#### **EXTRACT FROM COUNCIL MEETING MINUTES OF OCTOBER 24. 2017**

#### ZONING BY-LAW AMENDMENT FILE Z.17.017 FIRSTGREEN CORP. WARD 4 - VICINITY OF B<u>ATHURST STREET AND GEORGE KIRBY STREET</u>

## 4. ZONING BY-LAW AMENDMENT FILE Z.17.017 FIRSTGREEN CORP. WARD 4 - VICINITY OF BATHURST STREET AND GEORGE KIRBY STREET

# Conceptual Site Plan and Proposed Zoning

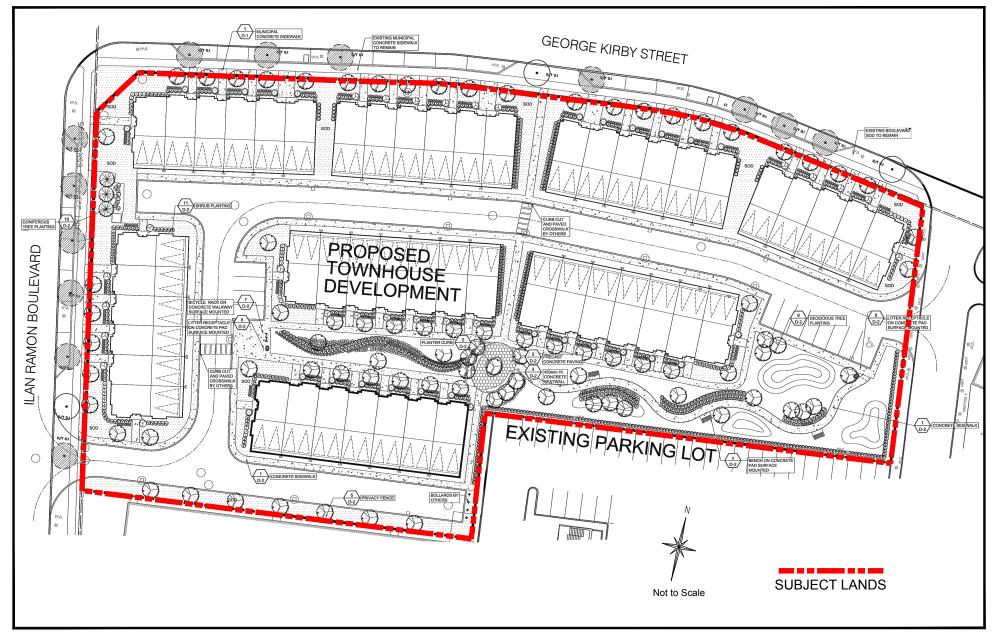
j.	Maximum Number of Townhouse Units in a Row	6 units	7 units (Blocks 6, 7 and 8, as shown on Attachment #3)
k.	Maximum Interior Garage Width	3.048 m	5.4 m

units in a row are proposed for Blocks 6, 7 and 8, as shown on

Attachment #3; Blocks 6, 7 and 8 either front onto, or are accessed by, a private common element condominium road; and the minimum facing distance between townhouse blocks ranges from 11.70 m to 15.32 m.  Townhouses are permitted on the subject lands, as the lands are located within 70 m of lands designated "Low-Rise Residential" in VOP 2010, specifically the existing street townhouse dwellings on the north side of George Kirby Street, as shown on Attachment #2.  The development proposal conforms to the building height, density and permitted uses of VOP 2010, but is not consistent with the development criteria prescribed by Section 9.2.3.2. Staff will continue to work with the Owner to address this policy requirement through the submission of an Urban Design Brief as required by Section 9.2.1.2.
Zoning	■ The subject lands are zoned C4 Neighbourhood Commercial Zone and C4(H) Neighbourhood Commercial Zone with the Holding Symbol "(H)" by Zoning By-law 1-88, as shown on Attachment #2, and are subject to site-specific Exception 9(1217), which permits a 12-storey apartment building with a total of 250 units on the subject lands.

MATTERS TO BE REVIEWED	COMMENT(S)
b.	Appropriateness of Proposed Zoning Exceptions	■ The appropriateness of the proposed rezoning of the subject lands to a RT1 Residential Townhouse Zone, together with the site-specific zoning exceptions identified in Table 1 of this report, will be reviewed in consideration of the existing and planned surrounding land uses. Particular consideration will be given to land use, built form compatibility, site organization, front, rear and interior side yard setbacks, and pedestrian and vehicular connections.

f.	Related Site Development File DA.17.041	■ The Owner has submitted related Site Development File DA.17.041 to permit the proposed townhouse development, should the subject Zoning By-law Amendment application be approved.
		The related Site Development Application will be reviewed in consideration of, but not limited to, the following matters:
		<ul> <li>pedestrian and barrier free accessibility;</li> <li>proper vehicular (including service vehicles such as fire and garbage trucks) turning movements on the proposed private road;</li> <li>appropriateness of the proposed lay-by parking spaces on</li> </ul>

MATTERS TO REVIEW	COMMENT(S)
	Ilan Ramon Boulevard and George Kirby Street; - appropriateness of the location of the proposed access driveway onto Ilan Ramon Boulevard; - appropriate site design and building materials, orientation of units and upgraded building elevations for units facing Ilan Ramon Boulevard and visible flankage elevations, landscaping, amenity area, snow storage, stormwater management, and servicing and grading; - the relationship between the facing distance of each townhouse block in order to maximize daylight, enhance landscaping and ensure privacy; - the number of units for each townhouse block, specifically Blocks 6, 7 and 8, as shown on Attachment #3; - accessibility and location of the proposed residential visitor parking spaces; and, - the relationship of the proposed built form, building setbacks and design with the immediate commercial land uses to the east and south, with attention to appropriate landscaping and noise attenuation.  ■ All issues identified through the review of the related Site Development file will be addressed together with the subject Zoning By-law Amendment application in a comprehensive technical report to a future Committee of the Whole Meeting.
